ADDENDUM 2 – JOB 22

TO: All prospective bidders on project NHU-1-981(105)115, Job No. 22 scheduled for the November 14, 2014 bid opening.

ADDENDUM 2

Traffic Signal System
 Intersection of Centennial Rd & 43rd Ave NE
 Bismarck, North Dakota
 Traffic Signal Layout

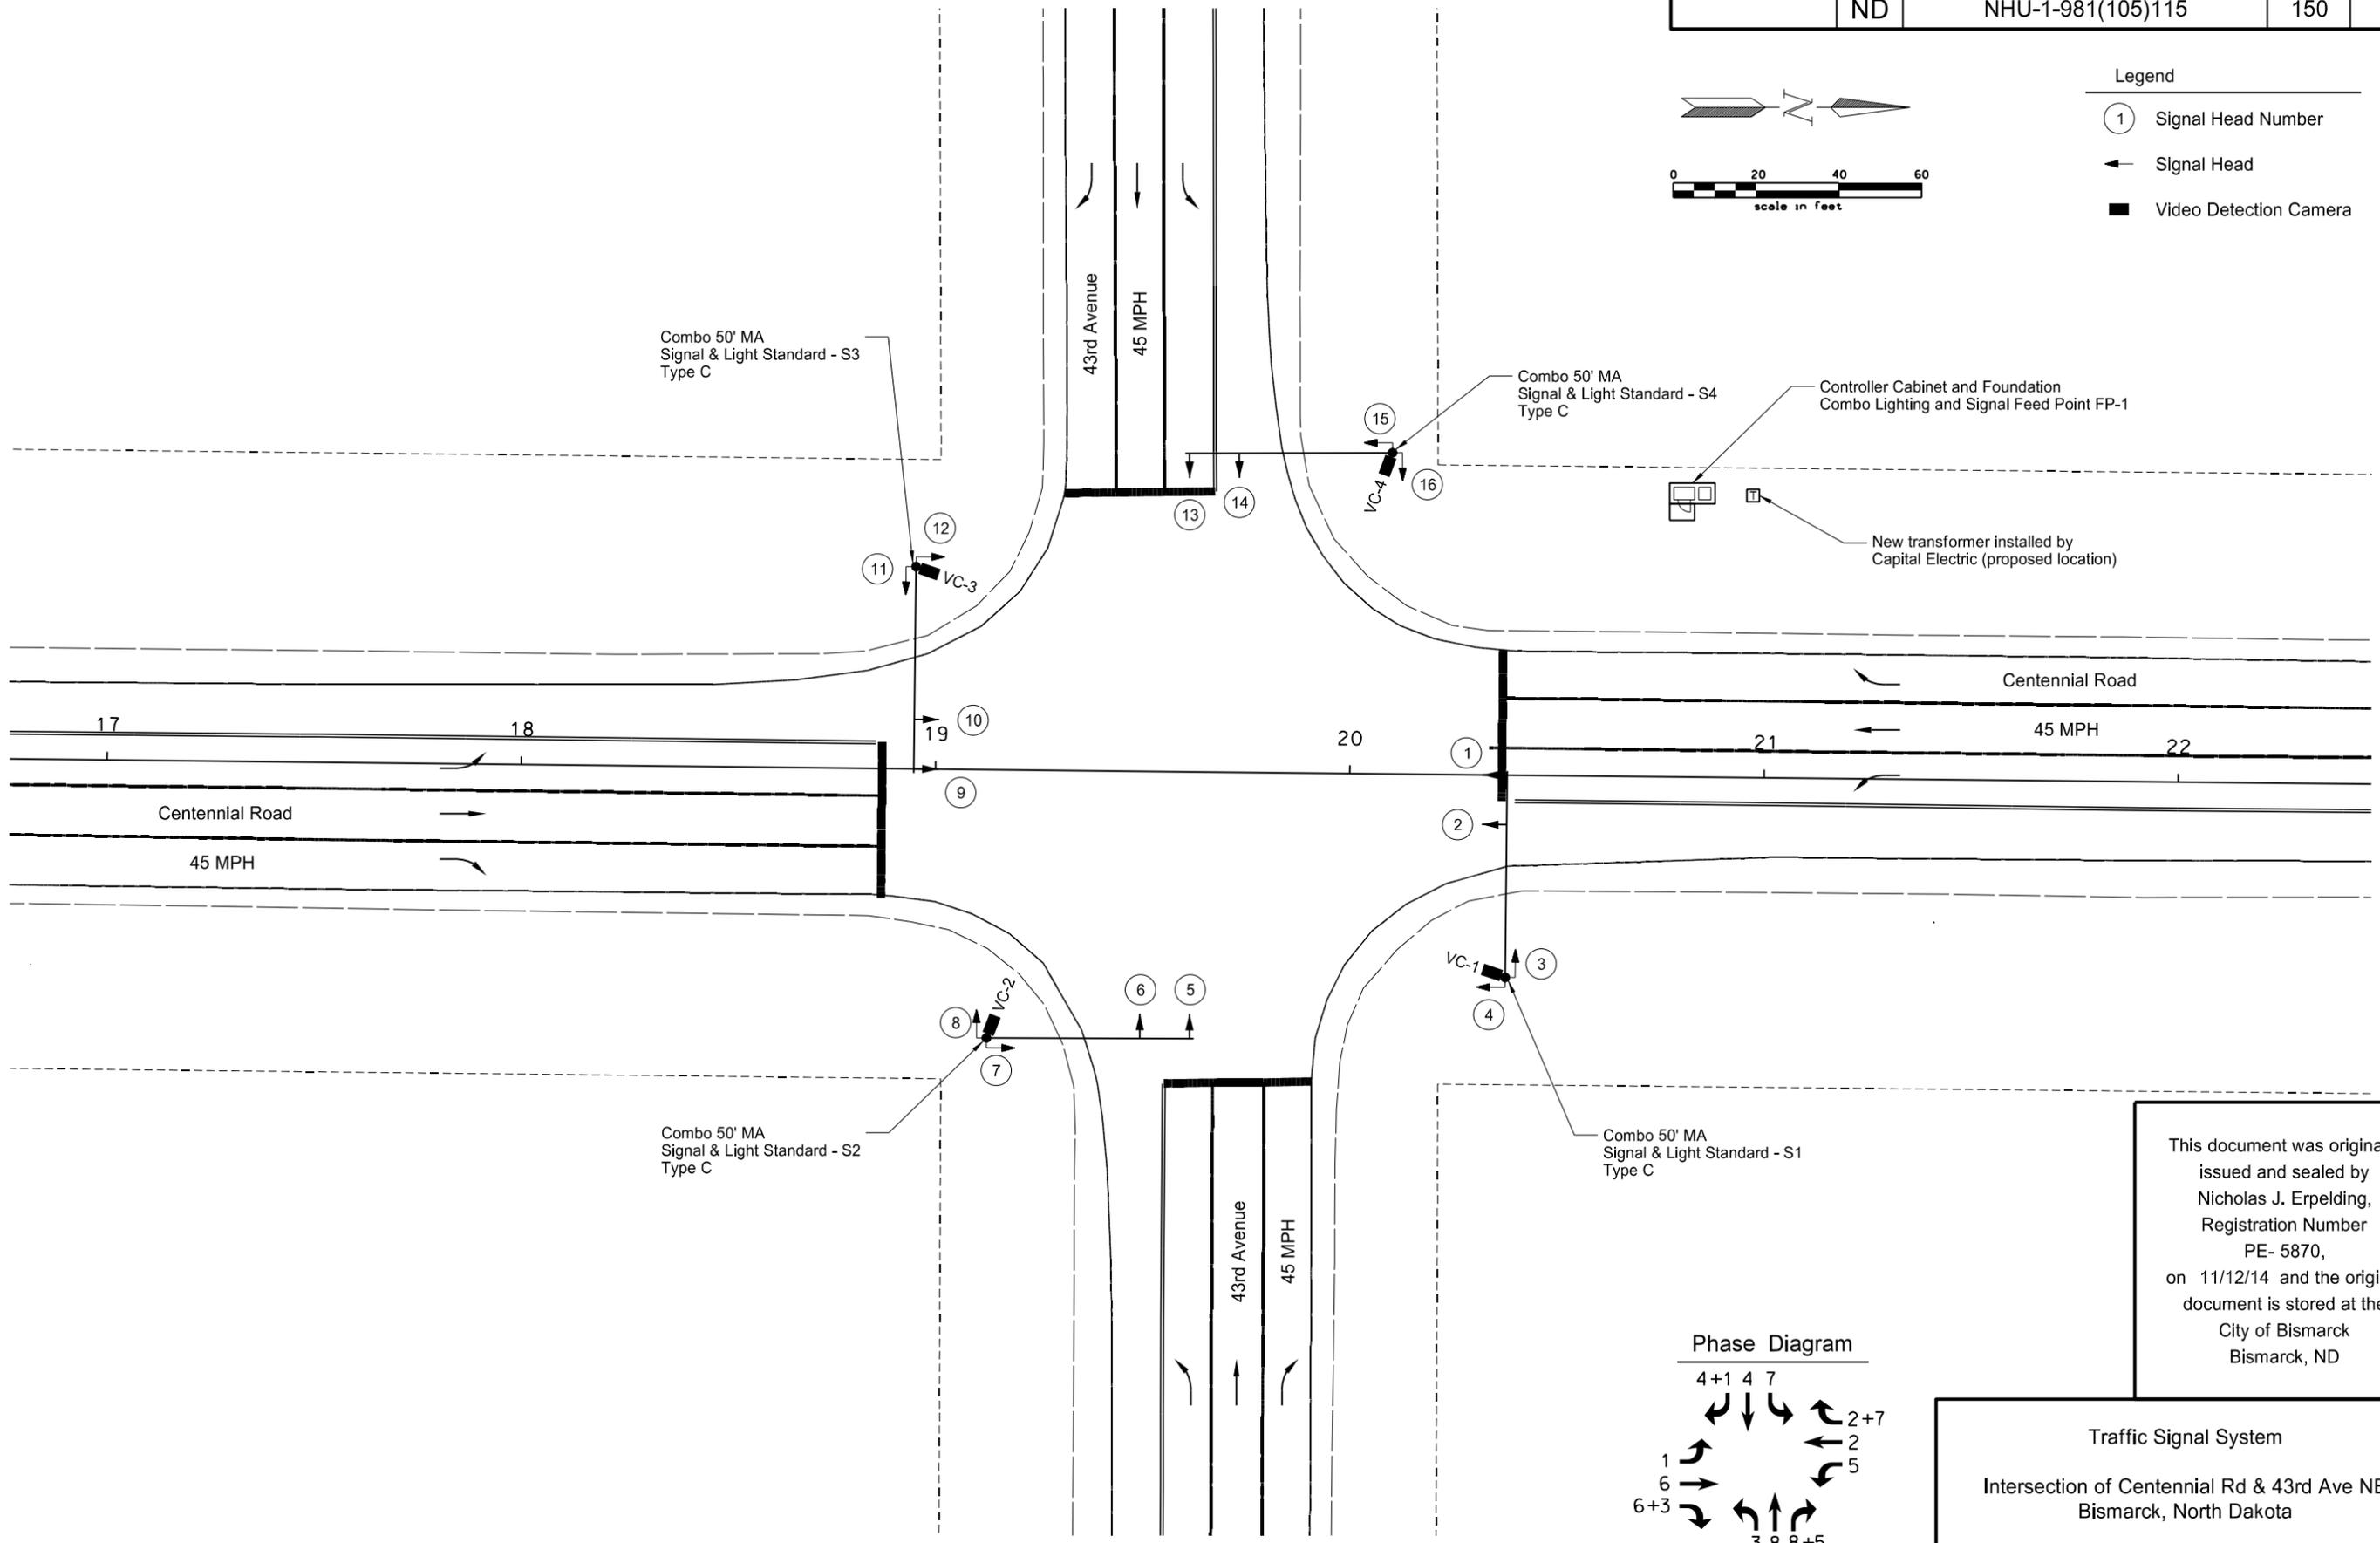
- Section 6, Sheet 2 (revised plan note 772-P03; feed point per City standards).
- Section 6, Sheet 3 (added plan note 772-P21; signal standards per AASHTO 5th Edition).
- Section 150, Sheet 1 (clarified that the feed point is to be furnished and installed).
- Section 150, Sheet 2 (clarified that the feed point is to be furnished and installed).
- Section 150, Sheet 13 (clarified that the feed point is to be furnished and installed).
